## AUDI SERVICE CENTER JSP23-40

Consideration of Preliminary Site Plan and Storm Water Management Plan approval at the request of Lithia Motors, Inc. for a partial demolition and renovation of an existing auto service center. The subject property is approximately 8.15 acres and is located north of Ten Mile Road on the west side of Haggerty Road in the B-3, General Business District. The applicant is proposing to demolish a part of an existing building in the southwest portion of the site and remodel the remainder of the building, in addition to the construction and reconstruction of an approximately 77,537 square foot parking lot. The remodeled service center would be used by the proposed Audi dealership abutting the south side of the site.

# PLAN REVIEW CENTER REPORT

**Review Date:** October 5, 2023  
**Review Type:** Preliminary Site Plan & Final Site Plan  
**Project Name:** JSP23-40 Audi Service Center  
**Location:** 50-22-24-476-022  
**Plan Date:** September 12, 2023  
**Prepared by:** James Hill, Planner  
**email:** [jhill@cityofnovi.org](mailto:jhill@cityofnovi.org); **Phone:** (248)-347-0547

DRAWN BY: B. Girbach  
 DESIGNED BY: T. Wood  
 APPROVED BY: J. Longhurst  
 DATE: September 12, 2023  
 SCALE: 1" = 20'  
 NFE JOB NO. 1921-06 SHEET NO. C4

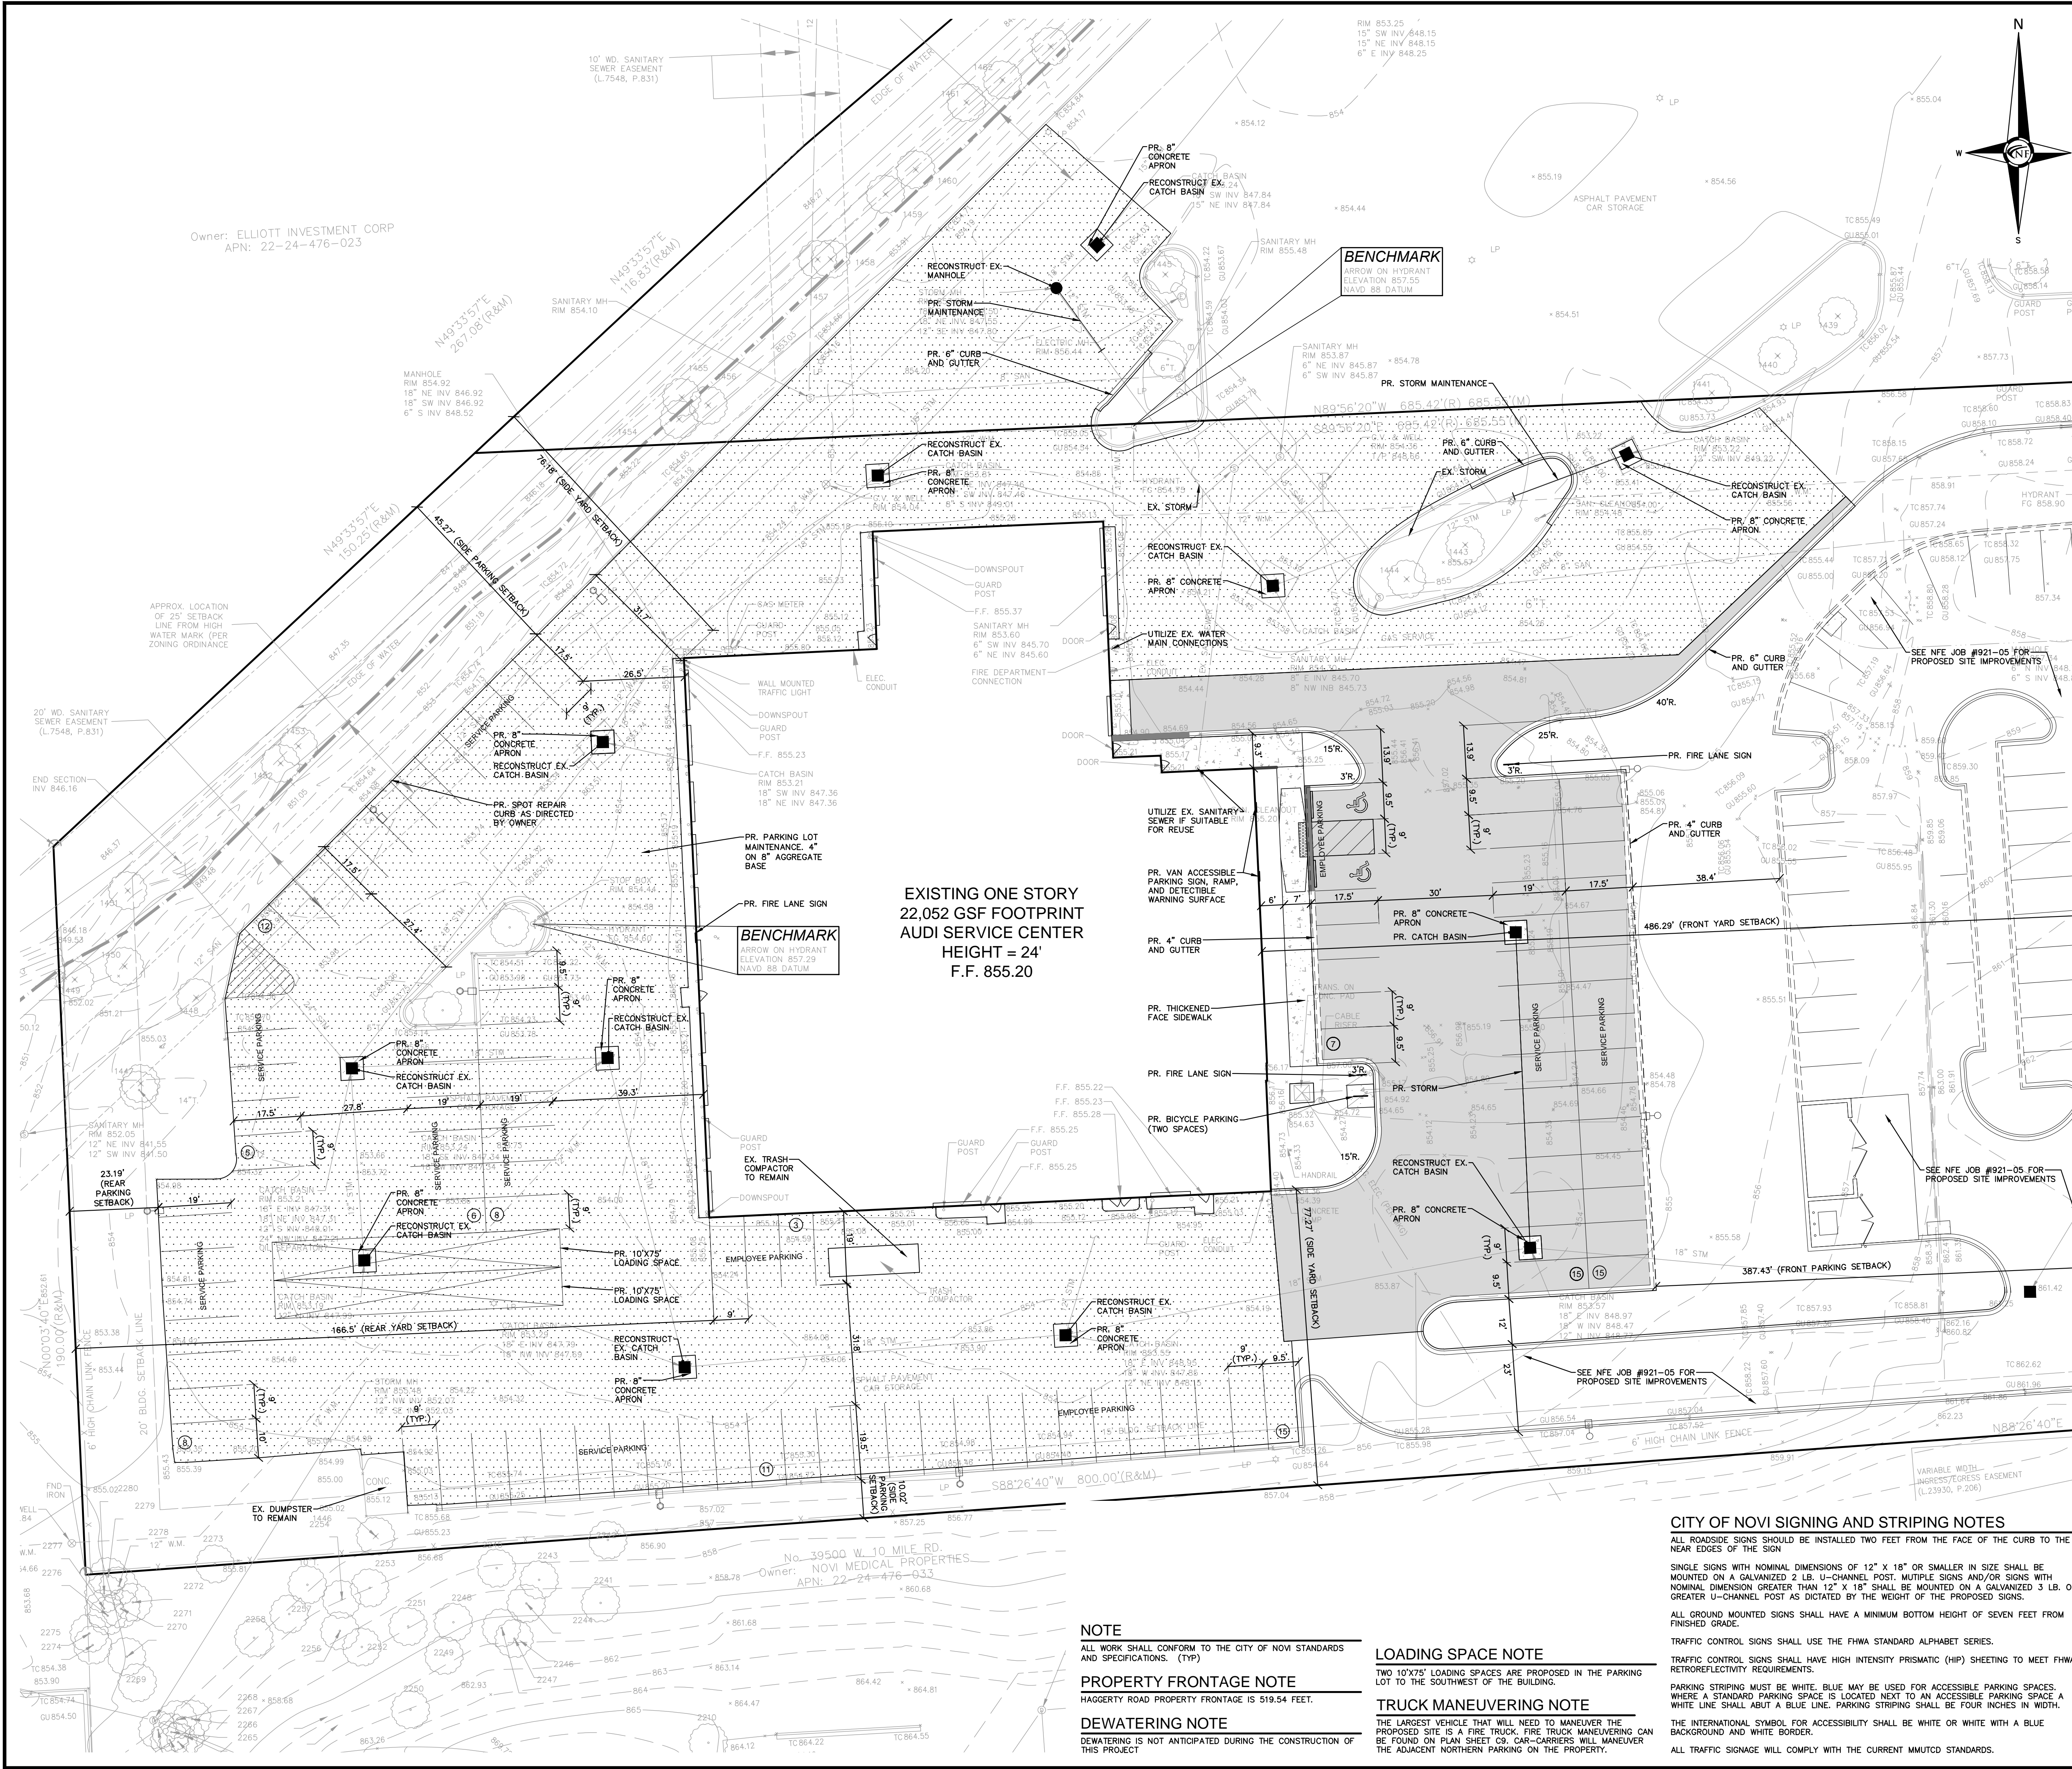
2. Loading Area (Sec. 5.4.2): The required size of the loading area is 10 ft per front foot of building, or in this case approximately 1,760 square feet. The plans show two 10' x 75' areas, or 1,500 square feet. **Please show the front footage of the building to determine the exact required loading space. It is likely that the loading space will still be deficient, and thus a variance from the ZBA will be required if not changed.**

1. On the revised final site plan, one parking stall will be removed from the 26-space bay of parking in favor of landscaped area.
2. The frontage of the building is 176.45'. This will be shown on plan sheet C4 on the revised final site plan. Shared loading zones for Porsche and Audi Service Shop are proposed. A waiver is requested to allow two loading zones (12'x75' each, 1,800 SF total) to be shared by Audi Service Shop and Porsche.
